ADDENDUM NO. 1

MARKET STREET IMPROVEMENTS and FIFTH STREET ACTIVE TRANSPORTATION STP-5507(607) & TAP-5445(613)

COUNTY OF JEFFERSON, MISSOURI

April 3, 2026

PLAN SHEET
 SHEET 2 OF 2
 KIMMSWICK GREAT
 STREETS PHASE 1

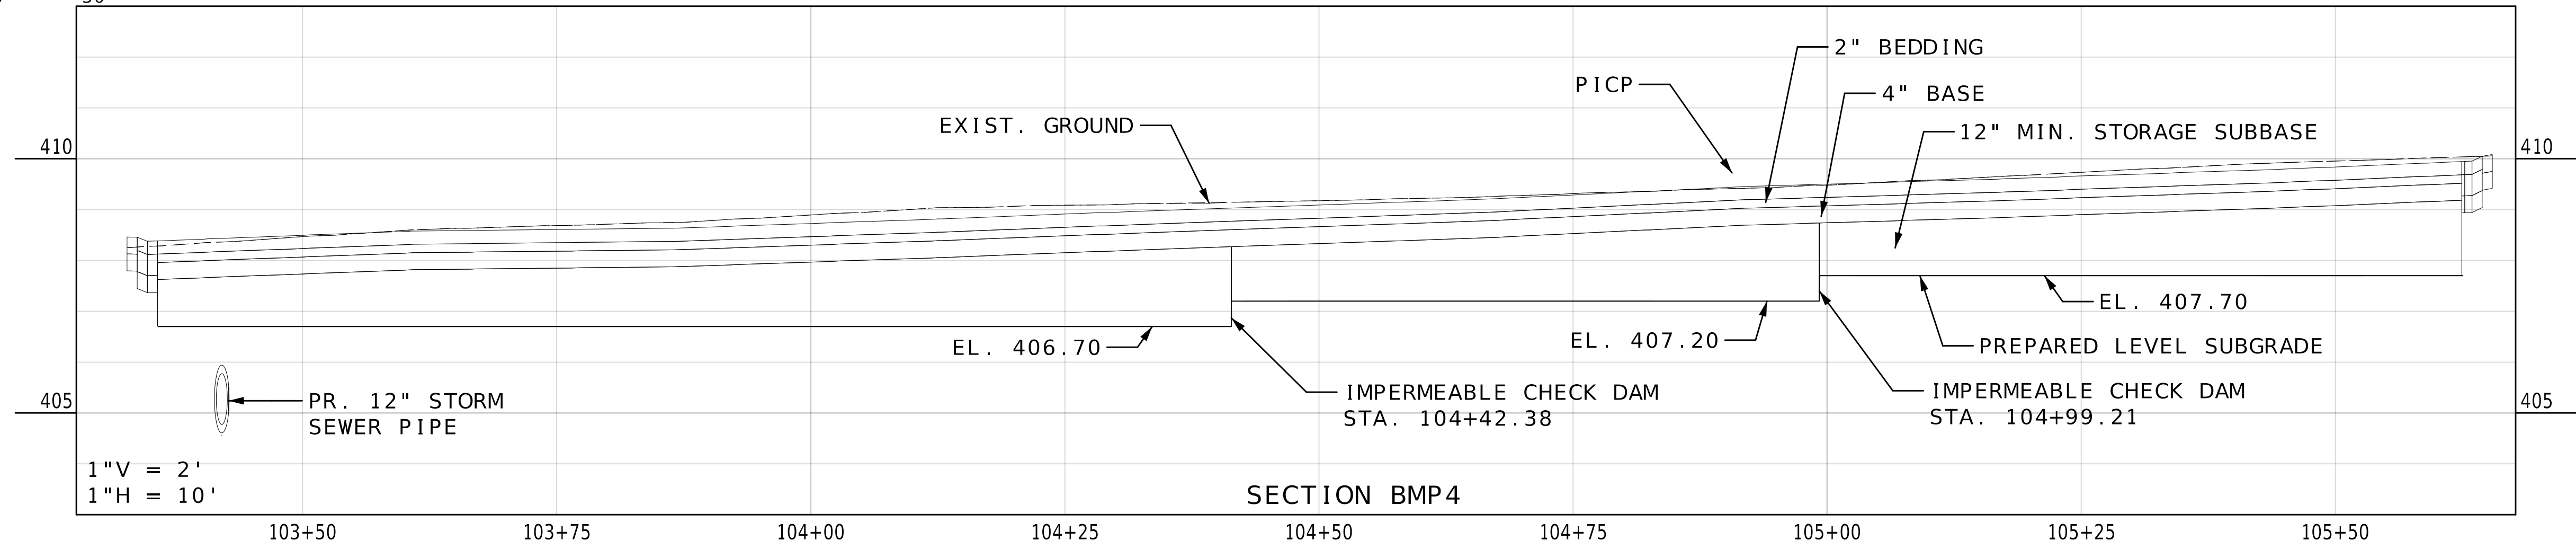
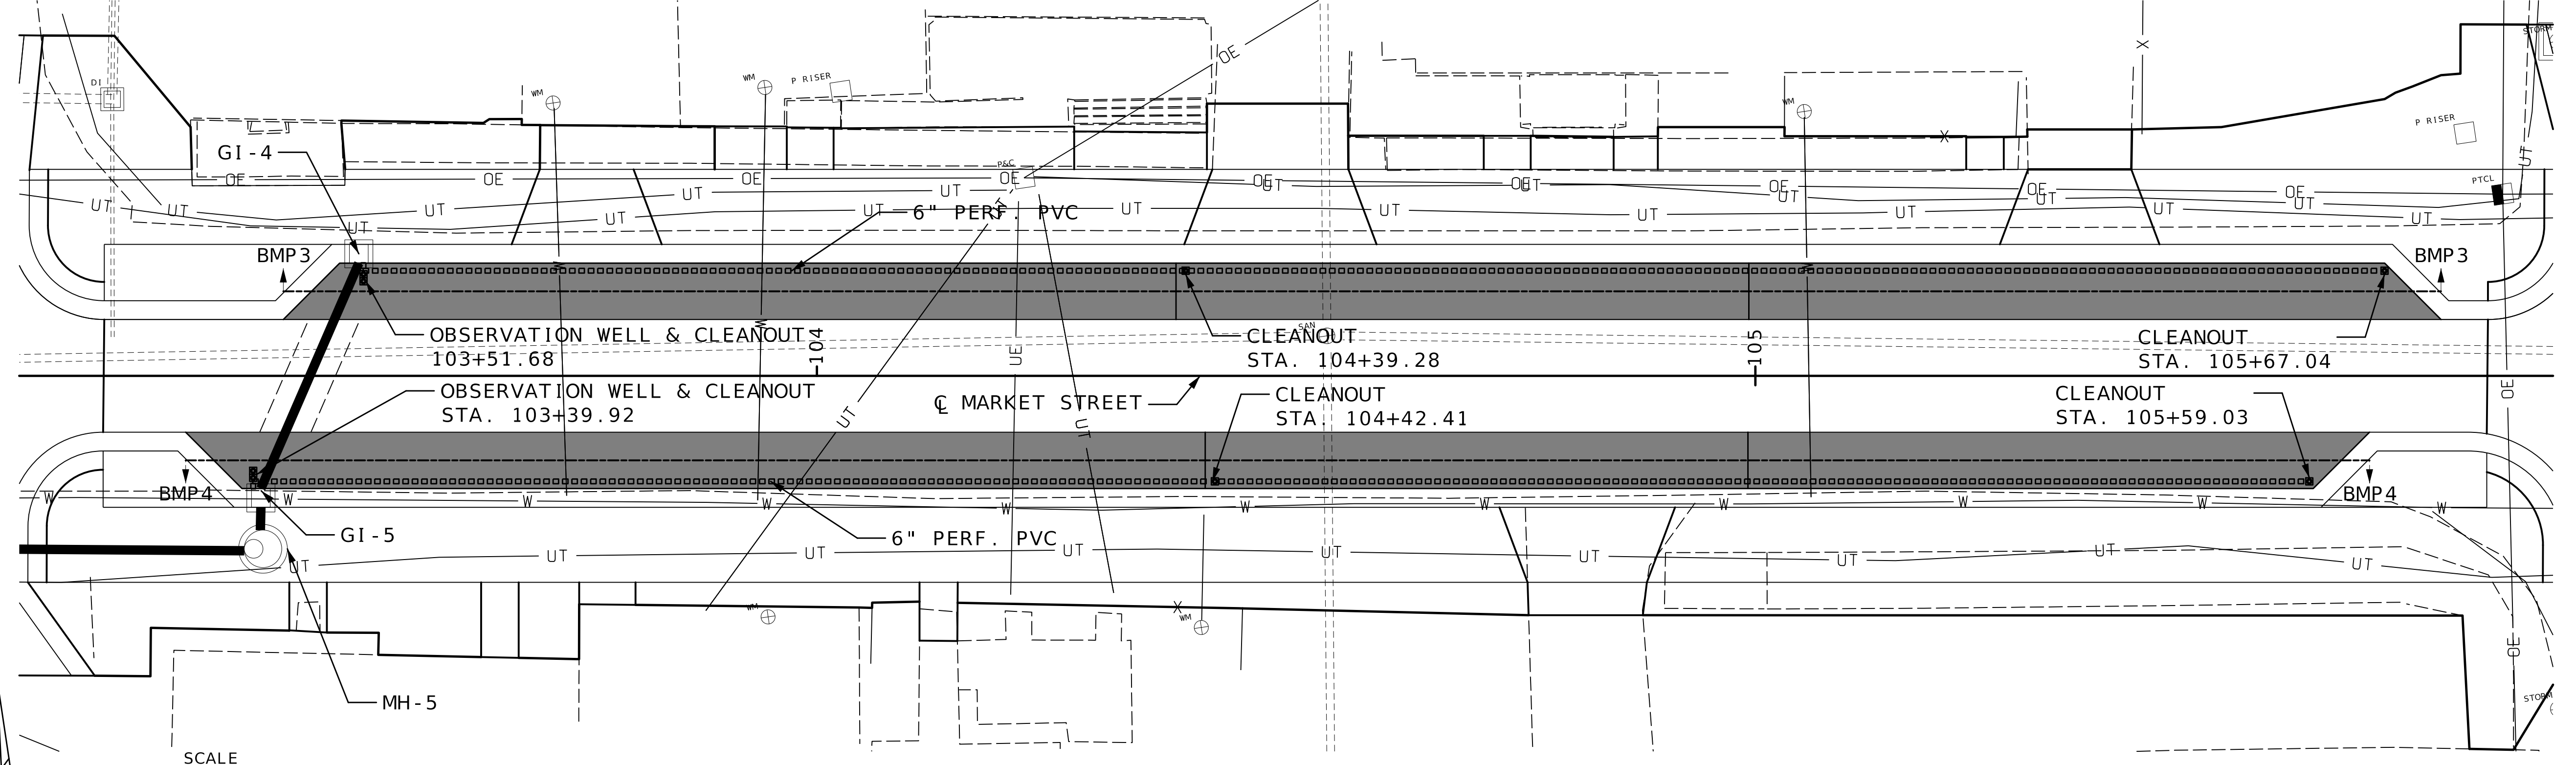
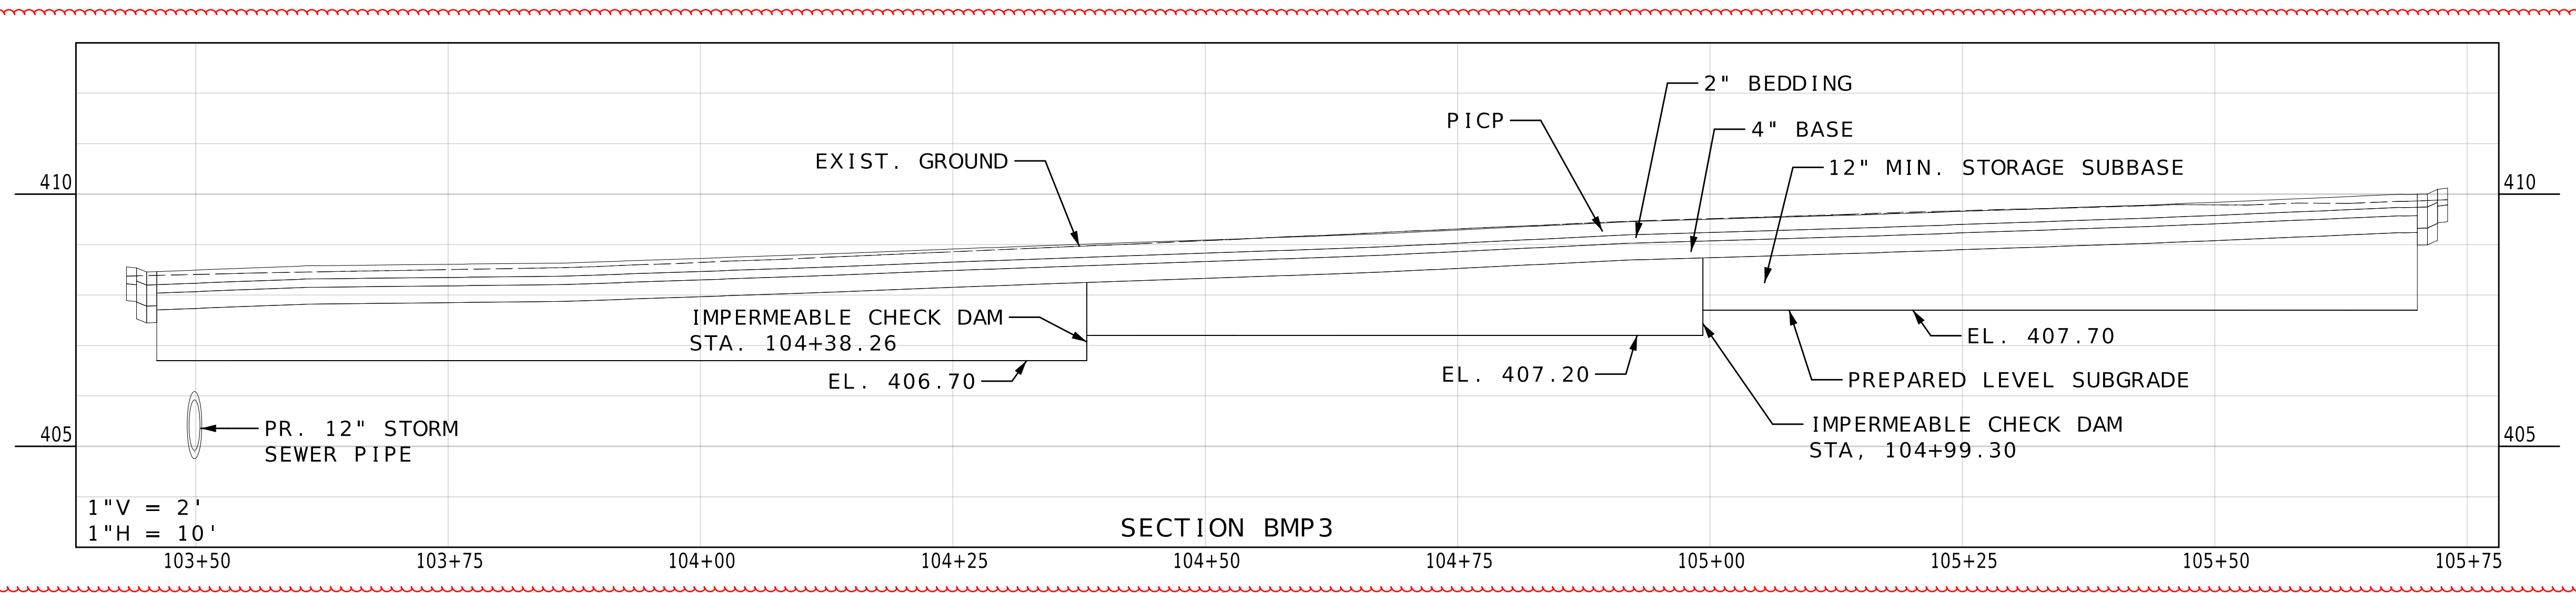
STP-5507(607) Updated Plan Sheets for Market Street Improvements: There are ten (10) plan sheets that have been updated. Quantity Sheet 1 of 11, 2 of 11, 5 of 11, and 6 of 11 were updated due to the sidewalk on Parcel 24 that was not included in the original quantities. Plan Sheet 2 of 2 has been updated to show the proposed sidewalk.
